NUMBER: 07-005-15

GROUP: Cooling

Intermittent Coolant Weepage From Upper Radiator Hose

2015 (LA) Dodge Challenger

Fig. 2 Radiator Hose Clamp Orientation

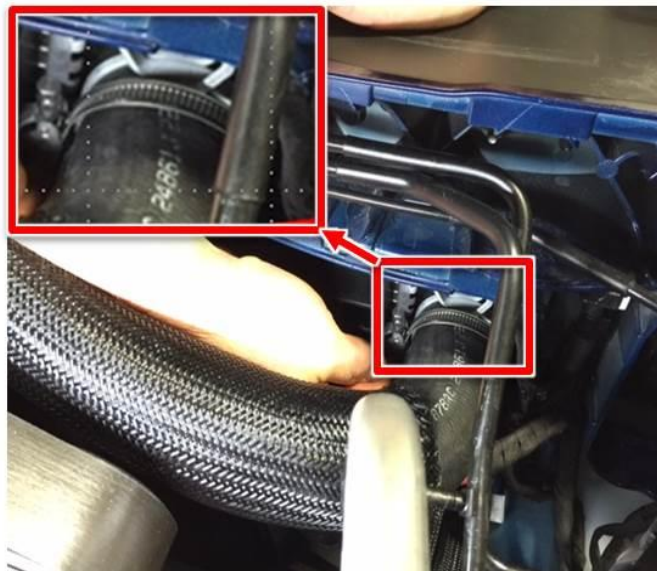
3. Inspect the upper radiator hose and verify it is properly seated onto the radiator. The end of the hose should be tight against the stop molded onto the radiator.
4. Open the new clamp and place it over the radiator hose. The hex head of the clamp should be facing up and be oriented on the core side of the radiator. See (Fig. 2).

NOTE: When installing the new clamp, the original will remain in place. The new clamp should be positioned between the existing clamp and the radiator outlet flange. Take care not to overlap the clamps.

Fig. 3 Hose Clamp Torque Limiting Head

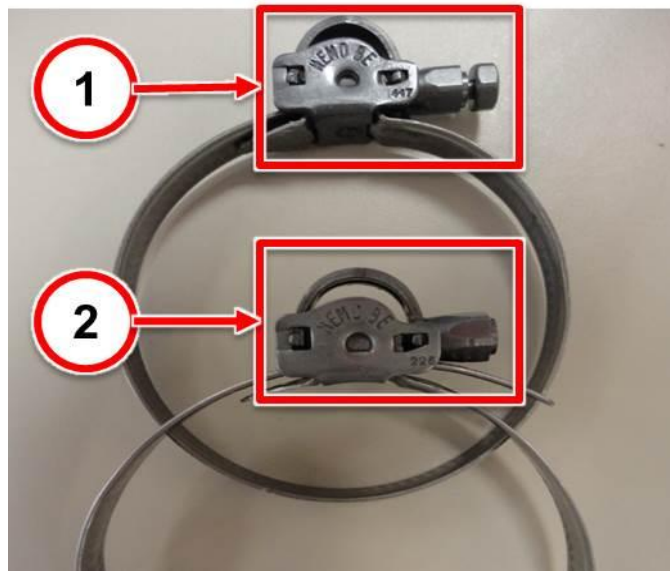
NOTE: The new clamp will have a torque limiting head. The head will break free once proper torque of 3 nm (26 in lb) is achieved. Care must be taken to ensure the socket used only engages the head of the bolt to prevent over tightening the clamp.

- 5. Using a 7mm shallow socket and swivel, tighten the new clamp until the torque limiting head breaks free. See (Fig. 3).
